Project Name Choctaw Point Container Terminal – Phase V Dock Extension

ADDENDUM NO. 5

**11411- Task 6 – Choctaw Point Container Terminal – Phase V Dock
Extension
Contractor Questions
Addendum No. 5**

DRAWING NO.: E-30

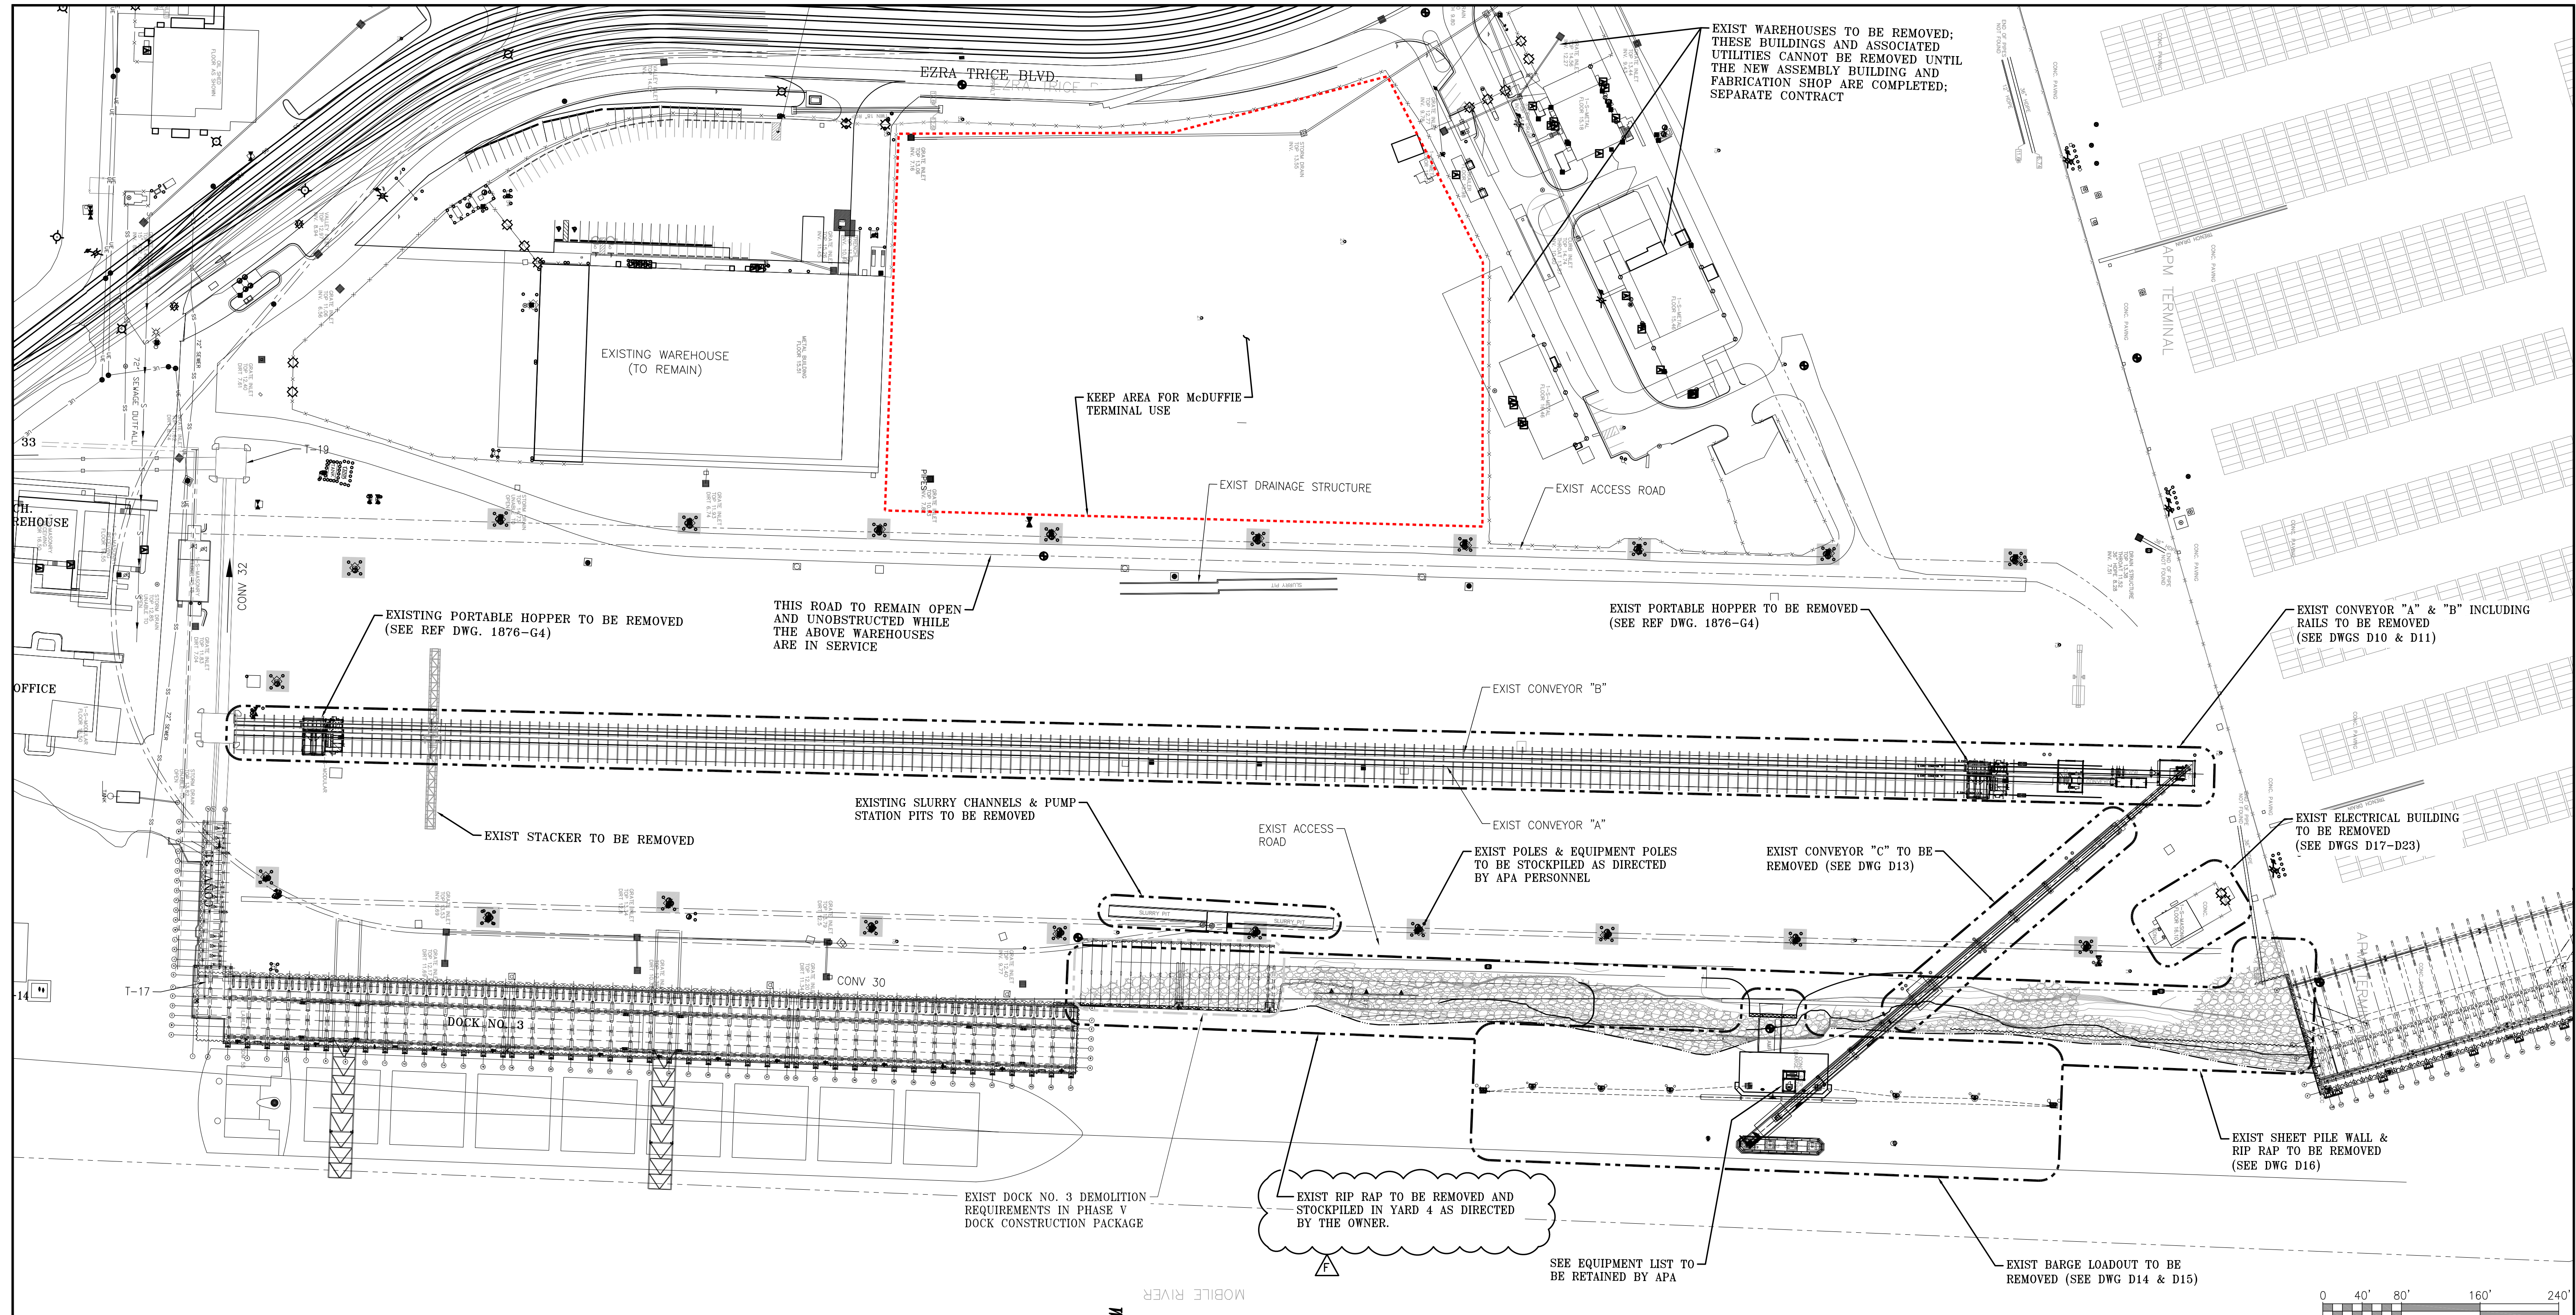
17. Please provide G.S.E. As-Built reference drawing E-30 listed in item number 4 of the bill of materials on drawing E12.
- Reference drawing E-30 is included in this addendum.

PROJECT NO: **4617** DWG NO: **D7** REV: **G**

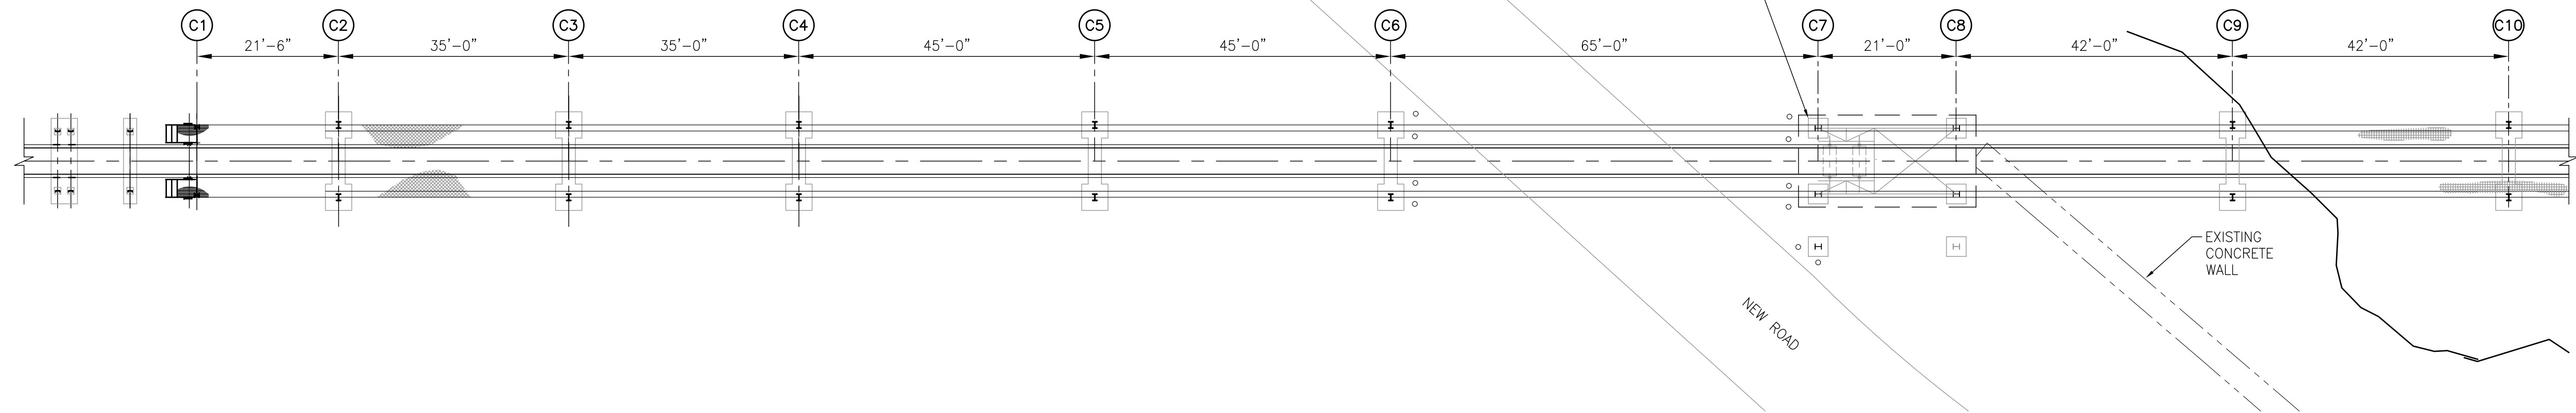
NO.	REVISION	DATE	APPD	CK'D	DRAWN	DATE	REVISION	NO.
G	ADDENDUM 5 REVISED NOTE	03-27-26	ECW	JEJ	RSG			
F	ADDENDUM 2 REVISED NOTE	02-11-26	RST	JEJ	RSG			
E	ISSUED FOR BID	01-14-26	JLH	JEJ	RSG			
D	100% DESIGN REVIEW	09-09-25	ECW	JEJ	RSG			
C	95% DESIGN REVIEW	08-08-25	JLH	JEJ	RSG			
B	60% DESIGN REVIEW	06-10-25	ECW	JEJ	RSG			
A	30% DESIGN REVIEW	04-11-25	ECW	JEJ	RSG

PROJECT NO: 4617 DWG NO: E2 REV: F

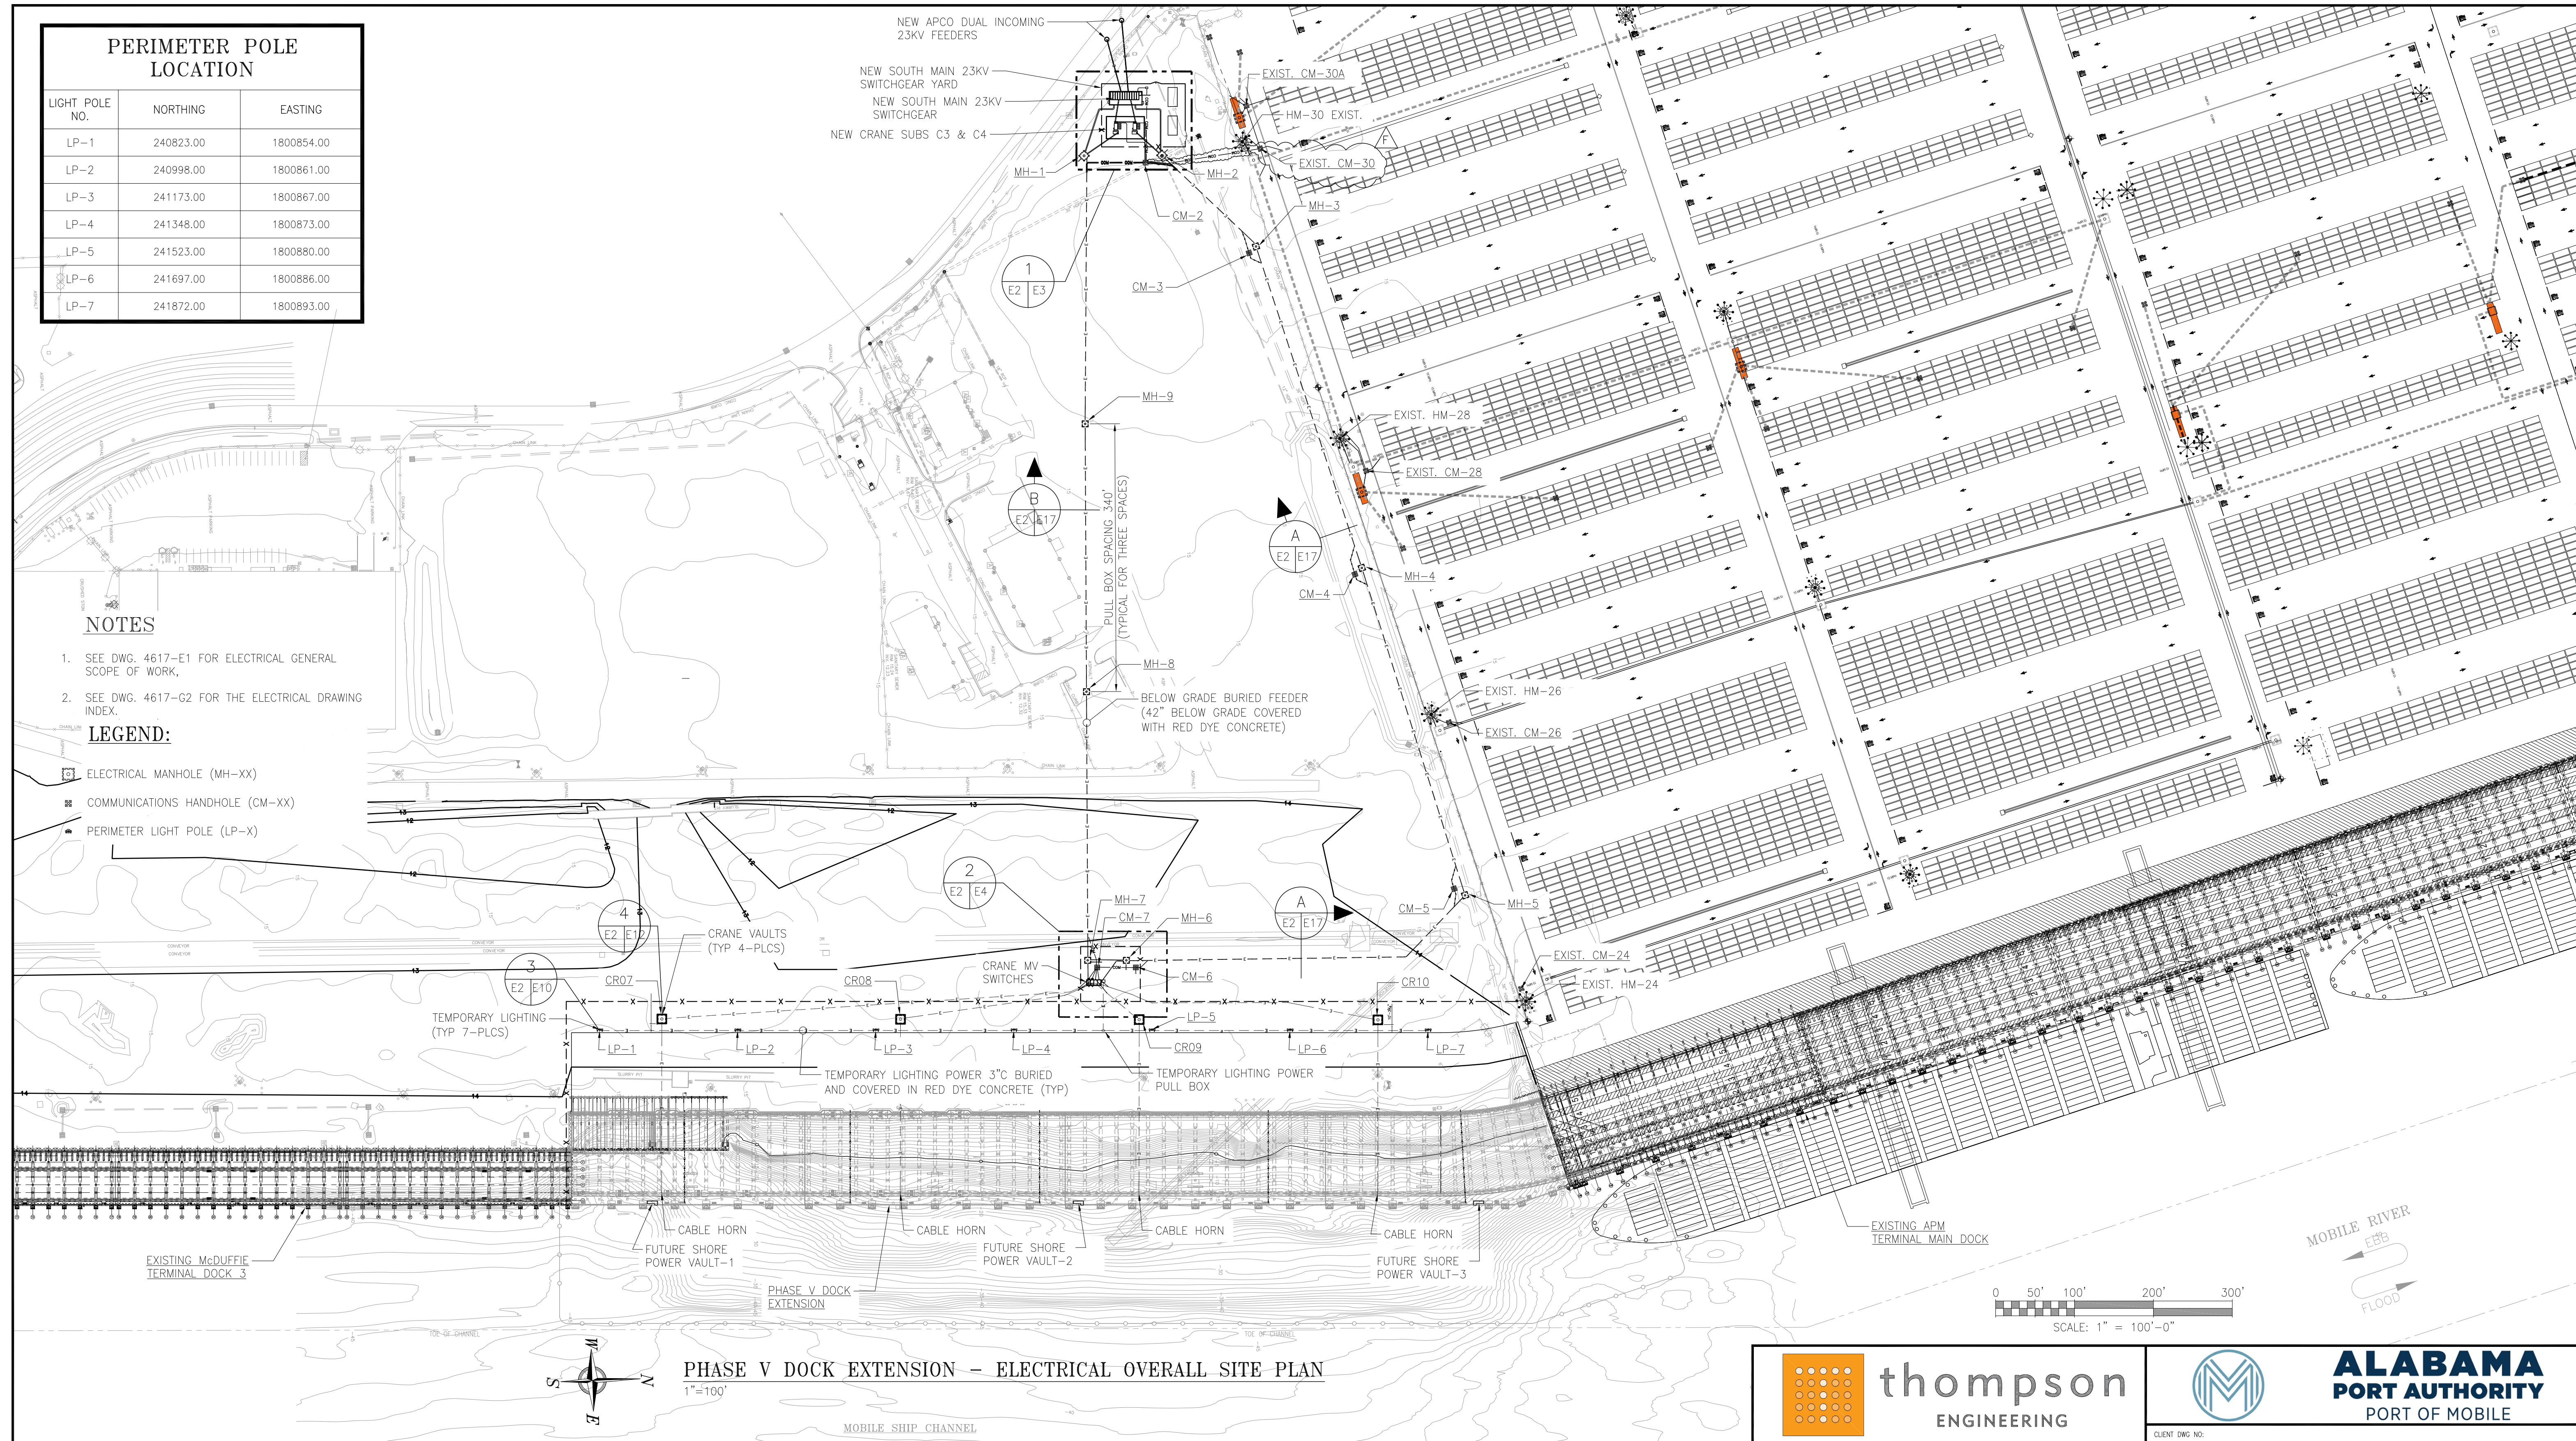
16. Note 6 on drawing E1 states that we are to core drill in existing communications manholes for new fiber optic conduit and cable. What drawing shows this new route and the existing manholes we have to tie into?

- Refer to revised electrical drawings E2 and E3 included in this addendum which indicates core drilling the existing MH-30 and installing a new underground duct bank to new CM-2.
